**Project:** Springfield City Hall Renovation (2021)  
**Title:** Addendum No. 02  
**Date:** October 20, 2023  
**From:** PIVOT Architecture  
**To:** Interested Bidders

**E100**

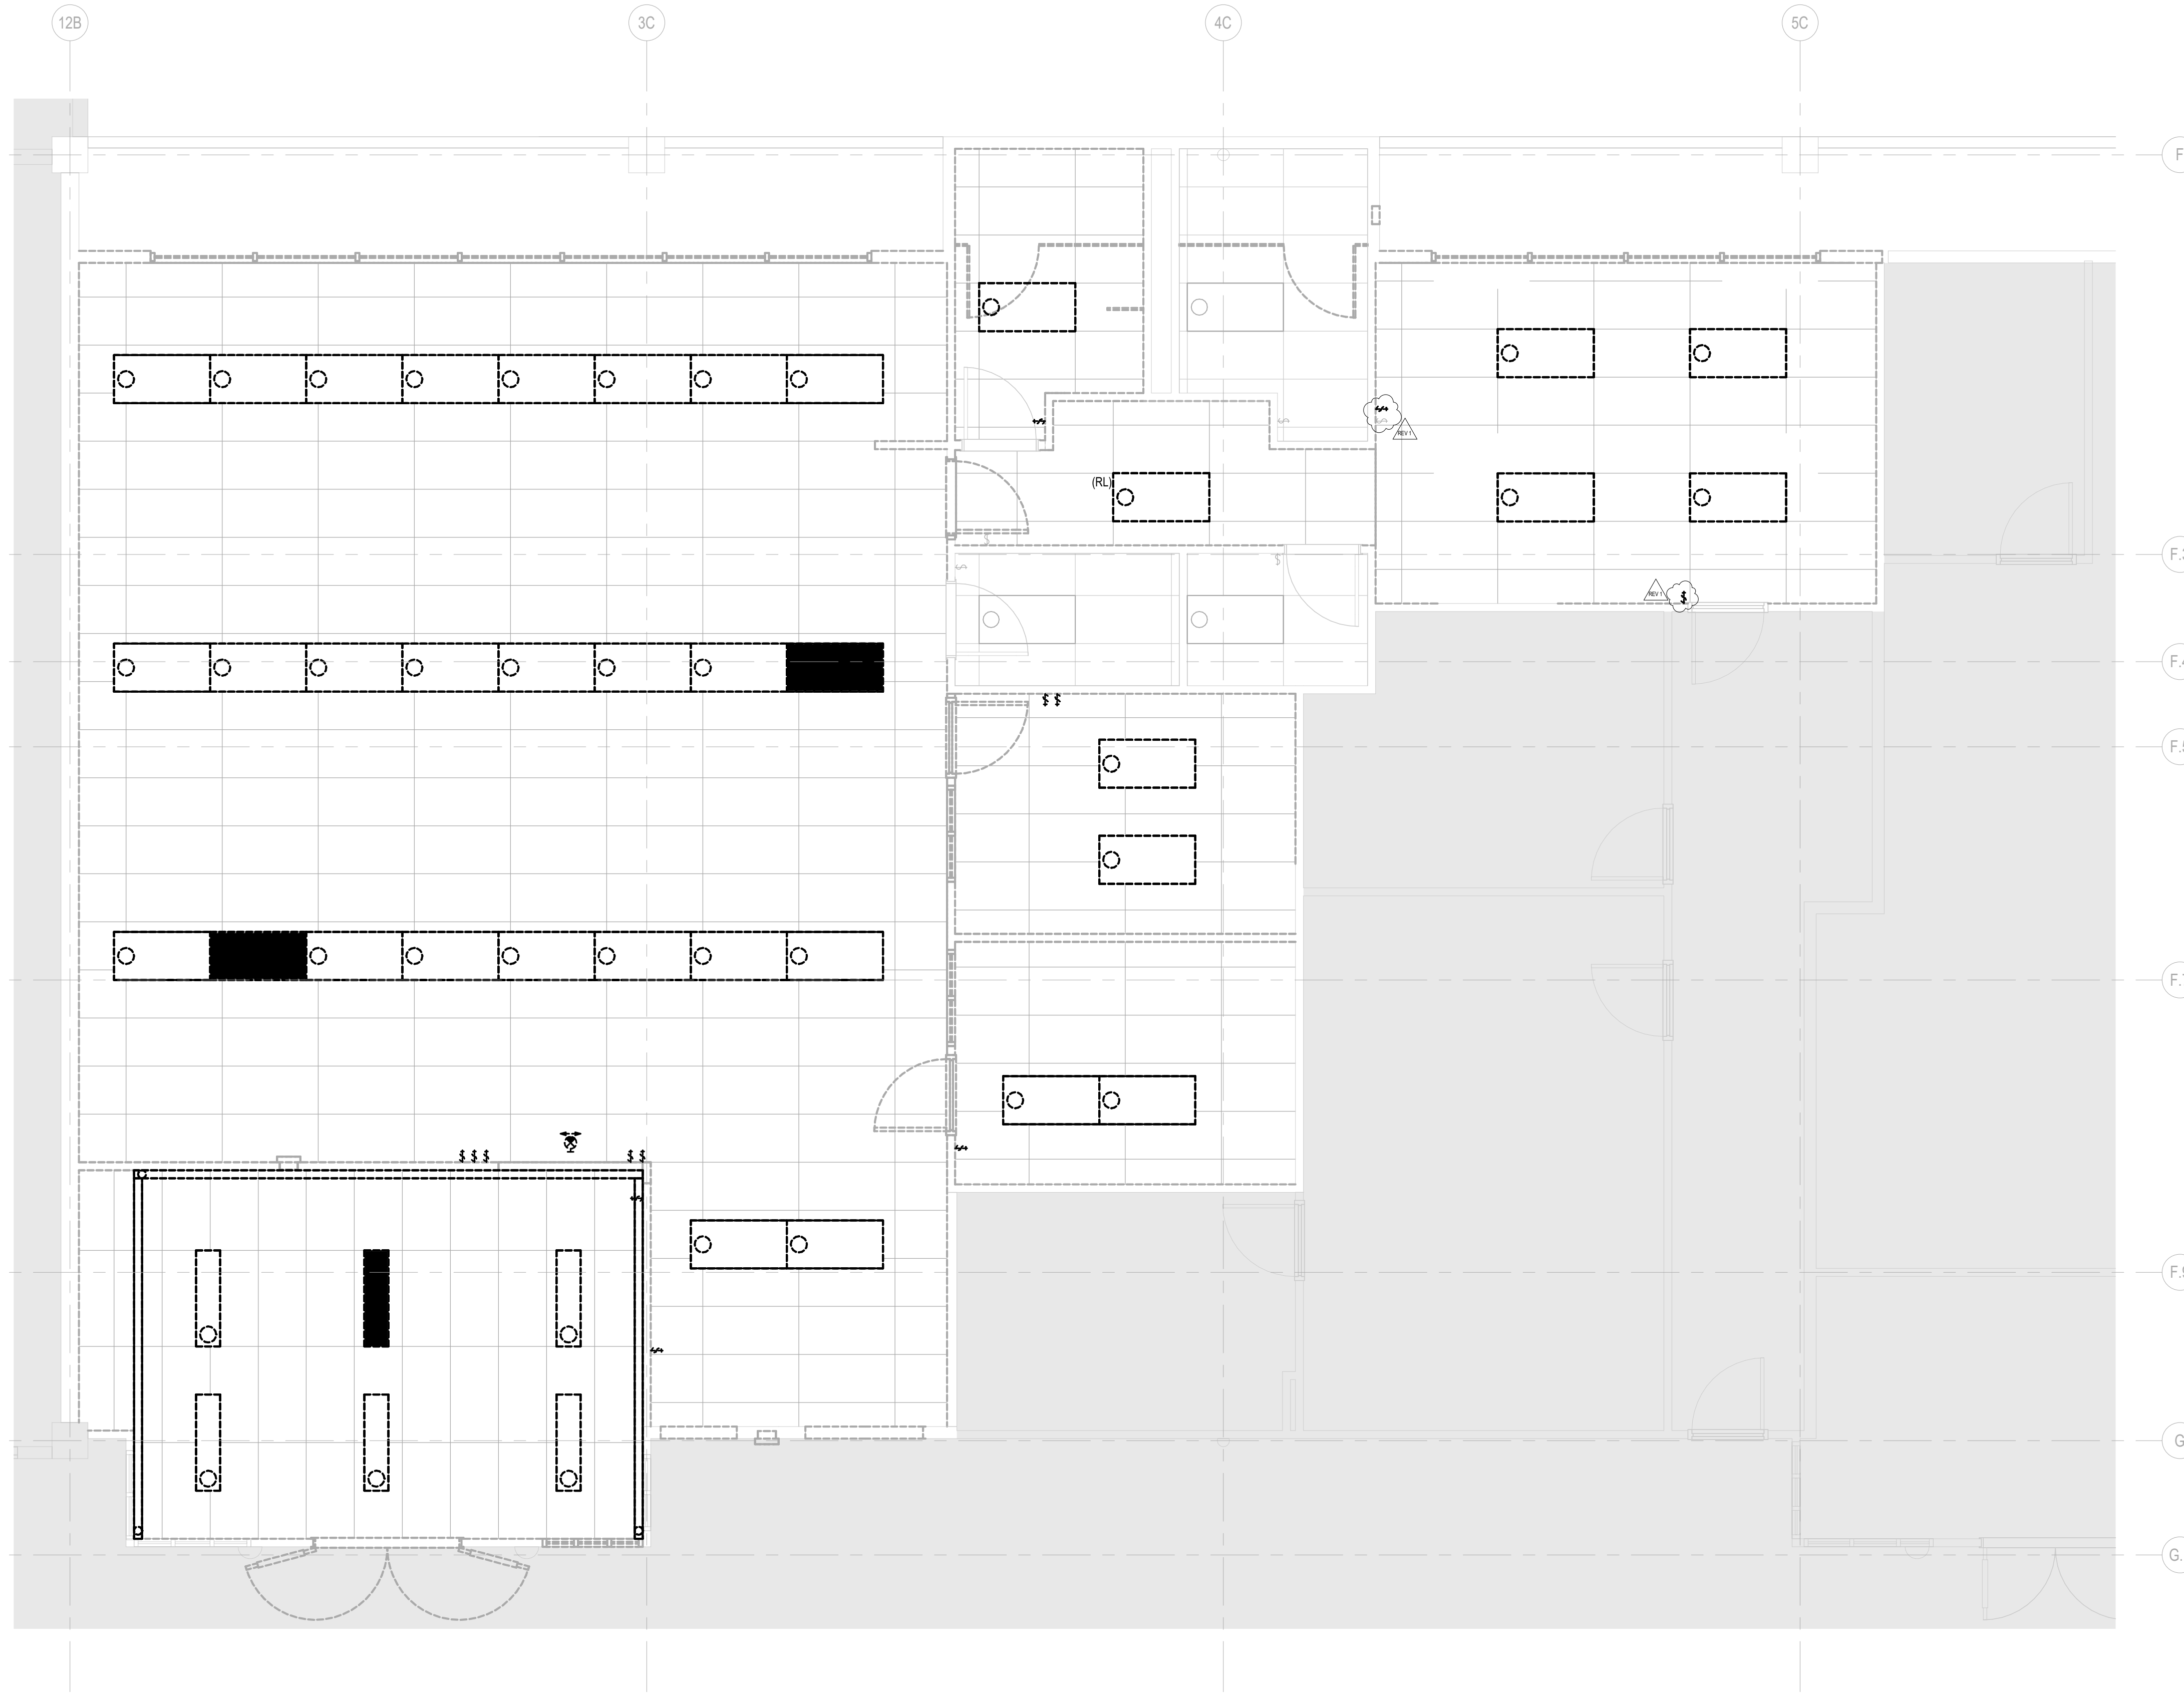
**A.** Alternate routing is acceptable. No Connectrac system.
- 1.9. **Q.** Is there a drawing that shows the location of existing switchboard SBE locations? I need this to be able to get a feeder length for the new feed to panel "PLA".

- 2.1. E100 – OVERALL PLAN
- 2.1.1. (New sheet) – Added location of fire alarm panel and switchboard SBE.
- 2.2. E103 – LIGHTING DEMOLITION PLAN – CM OFFICE dated 08.03.2023
- 2.2.1. (Reissued) – Demolition of existing break room lighting controls.
- 2.3. E111 – LIGHTING PLAN – CM OFFICE dated 08.03.2023
- 2.3.1. (Reissued) Connected A1 fixtures to backup power for emergency egress, added lighting controls.
- 2.4. E112 – LIGHTING PLAN – LIBRARY dated 08.03.2023
- 2.4.1. (Reissued) Display of existing exit signage

**A.** See Addendum 2 drawings
- 1.10. **Q.** Is there a feeder schedule as we are to install a new feeder (100B) to panel "PLA" I cannot find what size conduit and wire is required?

**2 BASE BID CIRCULATION DESK LIGHTING PLAN**  
1/8" = 1'-0"

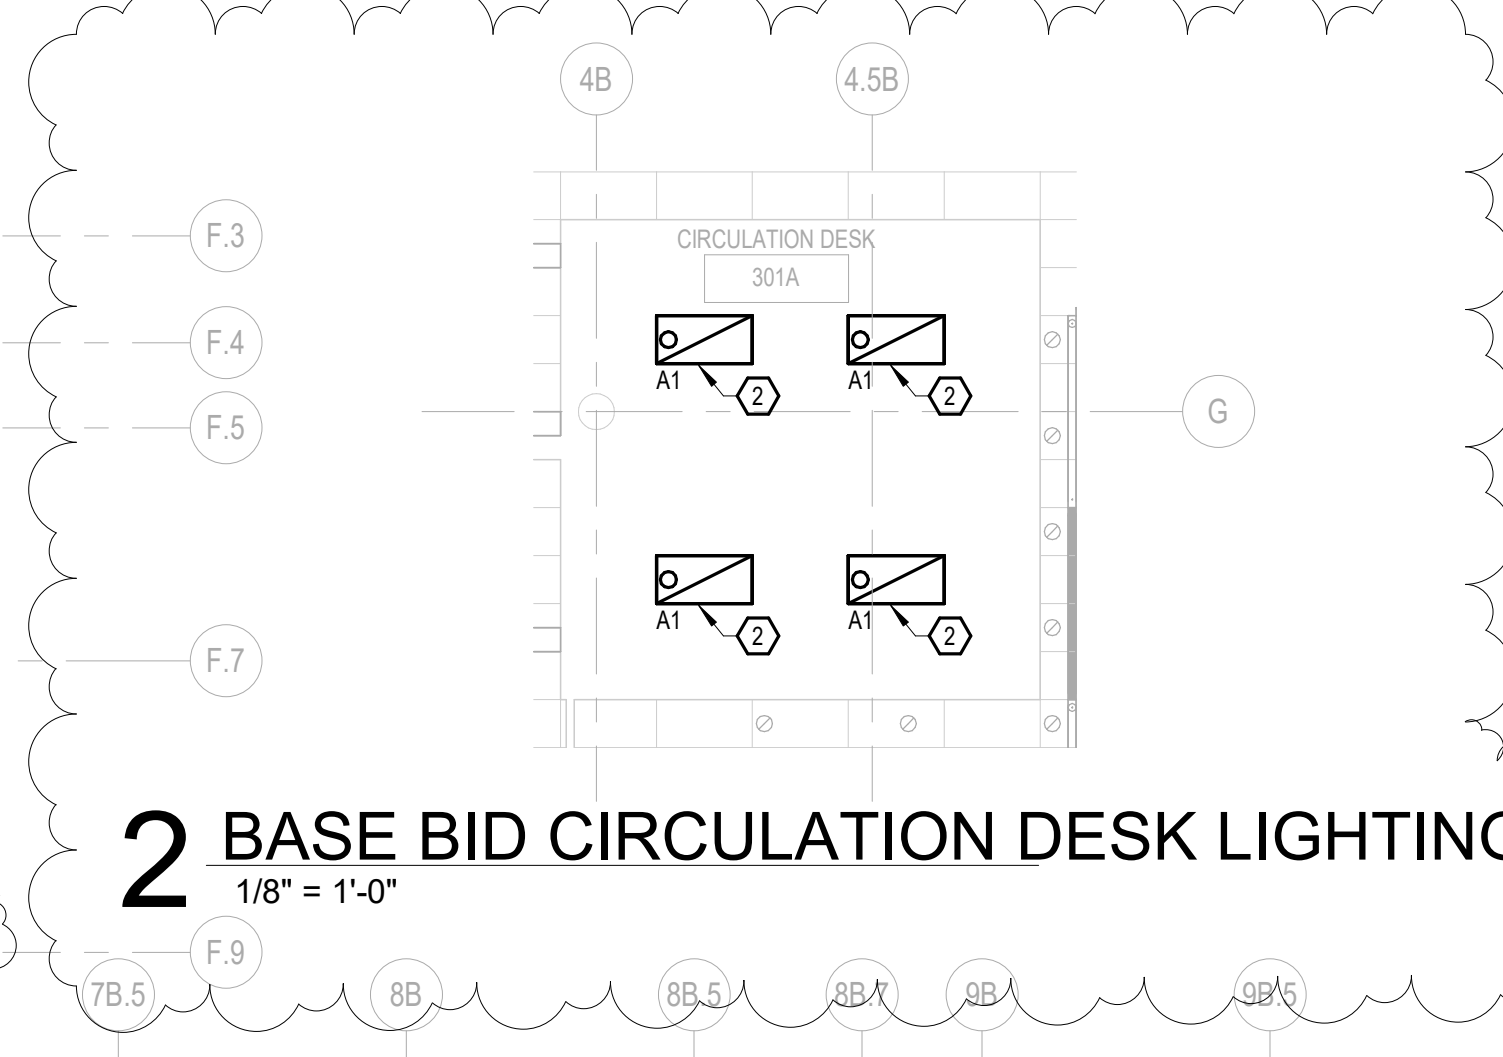
**A.** See Addendum 1 issued 10.18.2023
- 1.7. **Q.** Div 00 1000 21 B. a. states base bid to be new LED 2x4 lay in fixtures in the circulation desk area. This is not shown on drawings. How Many are we figuring and are they A1 fixture types? Please advise.

- 2.5. E112 – LIGHTING PLAN – LIBRARY
  - 2.5.1. (Reissued) Provided A1 fixtures and layout for base bid.
- 2.6. E121 – FLOOR PLAN - CM OFFICE dated 06.22.2023
  - 2.6.1. (Reissued) – Revised break room circuits at kitchenette to be fed from panel FAA.
  - 2.6.2. (Reissued) – Identified location of panel FAA.
- 2.7. E121 – FLOOR PLAN – CM OFFICE
  - 2.7.1. (Reissued) – Provided scope for ADA door operator connections.
- 2.8. E621 – WIRING DIAGRAMS
  - 2.8.1. (Reissued) Added language for fuse replacement at switchboard SBE feeding new panel PLA.

**A.** Base bid layout of 2x4 fixtures included in Addendum 2 drawings.

**1 ONE-LINE DIAGRAM**  
NOT TO SCALE

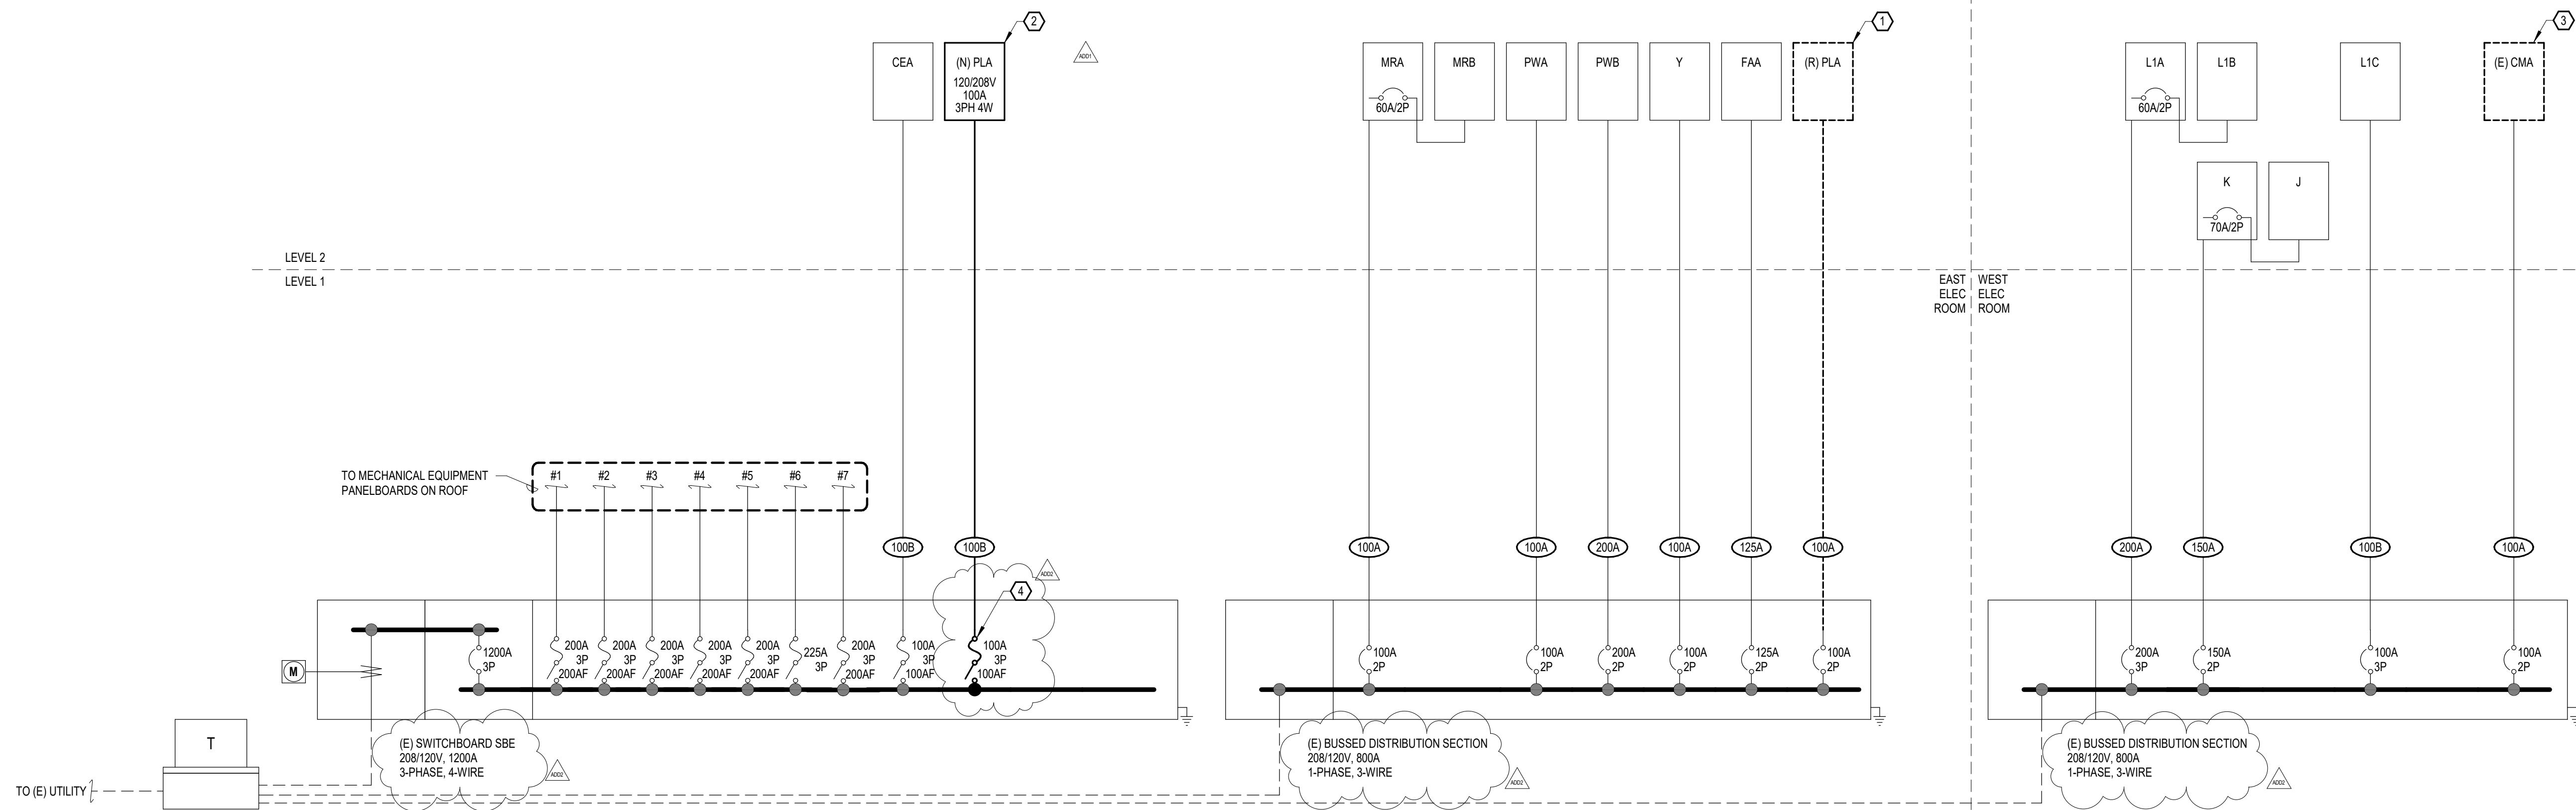
**B.** A. See Addendum 1 issued 10.18.2023
- 1.11. **Q.** The breaker or fuses that supply a new feeder (100B, sheet E621) for panel "PLA" already in switchboard "SBE" or do we need to supply this?

- DEMOLISH EXISTING PANELBOARD 'PLA' AND FEEDERS. REFER TO 1/E101.
- PROVIDE NEW 42-CIRCUIT PANELBOARD IN NEW LOCATION. PROVIDE NEW FEEDERS AS INDICATED AND SERVE PANELBOARD FROM EXISTING SPARE FUSED SWITCH IN SWITCHBOARD 'SBE'. REFER TO 1/E121 AND PANEL SCHEDULES FOR ADDITIONAL INFORMATION.
- REMOVE PANELBOARD 'CMA'. RETAIN FEEDERS & BRANCH CIRCUITS FOR RECONNECTION TO NEW PANELBOARD. PROVIDE NEW 42-CIRCUIT PANELBOARD IN PREVIOUS LOCATION. REFER TO 1/E122 AND PANEL SCHEDULE FOR ADDITIONAL INFORMATION.
- PROVIDE NEW 100A FUSES IN EXISTING SWITCH.
